Sapphire Beach Development Addendum to Coastal Hazard, Water Management and Services Assessment Report

Attentus
Sapphire Beach

Proposed Stormwater Upgrade
scale | for A3 date | month 2005

Figure 01

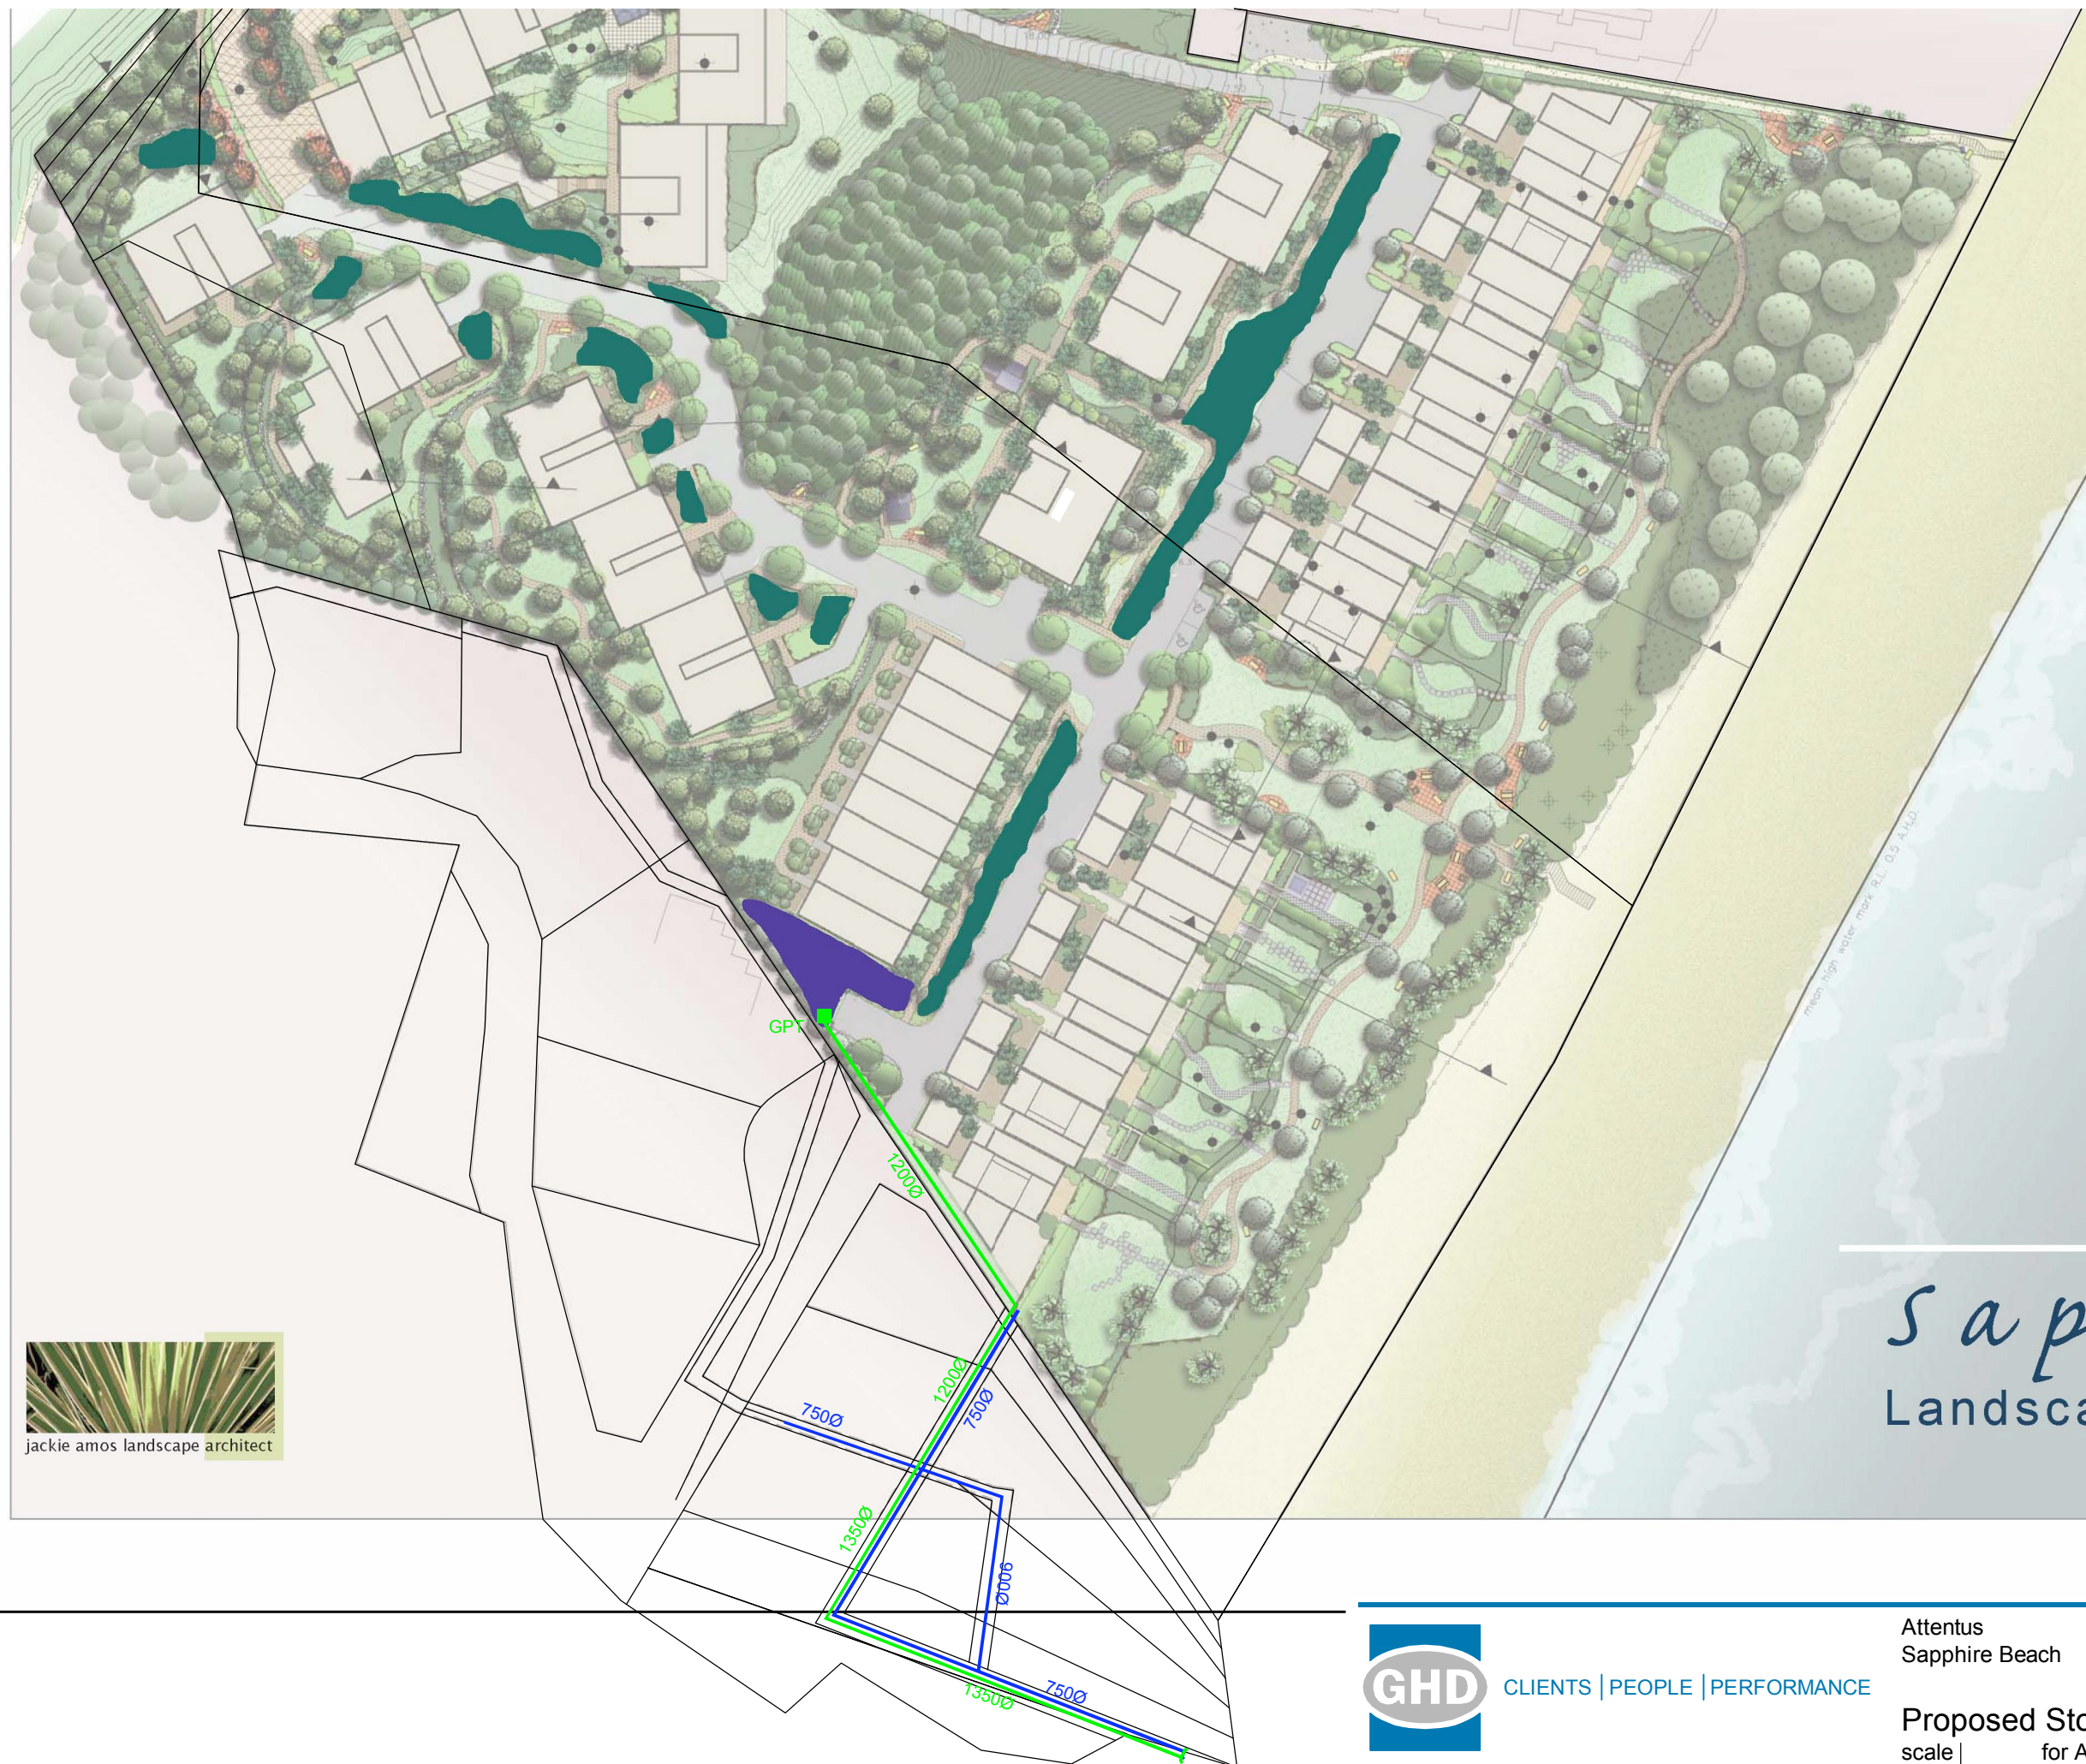
The pipe system south of the subject site consists of a 750mm diameter pipe, which then transitions to a 900mm diameter pipe downstream of Pit 2 (refer Figure 1, attached). To safely convey the above 100 year storm flow, the 750mm and 900mm diameter pipes would be upgraded to 1200mm and 1350mm diameter respectively.

With the upgrade of these pipes to cater for the increased flow, upgrading of the existing headwall is required and this will also include measures to ensure that scouring does not occur at the outlet. The extent of this work would be determined as part of the detail design process.

It is proposed to incorporate a gross pollutant trap (GPT) upstream of the connection into the existing stormwater system prior to it passing through into the adjacent property. The inclusion of this structure will allow for the removal of gross pollutants and coarse sediment from runoff prior to discharge into the Marine Park. To further assist in the removal of coarse sediment, a small area of settlement storage has been nominated to be included immediately upstream of the GPT.

Figure 1, attached, indicates the location of the proposed water quality treatment devices as well as the location for the upgraded stormwater pipeline through the existing easement within the adjacent property.
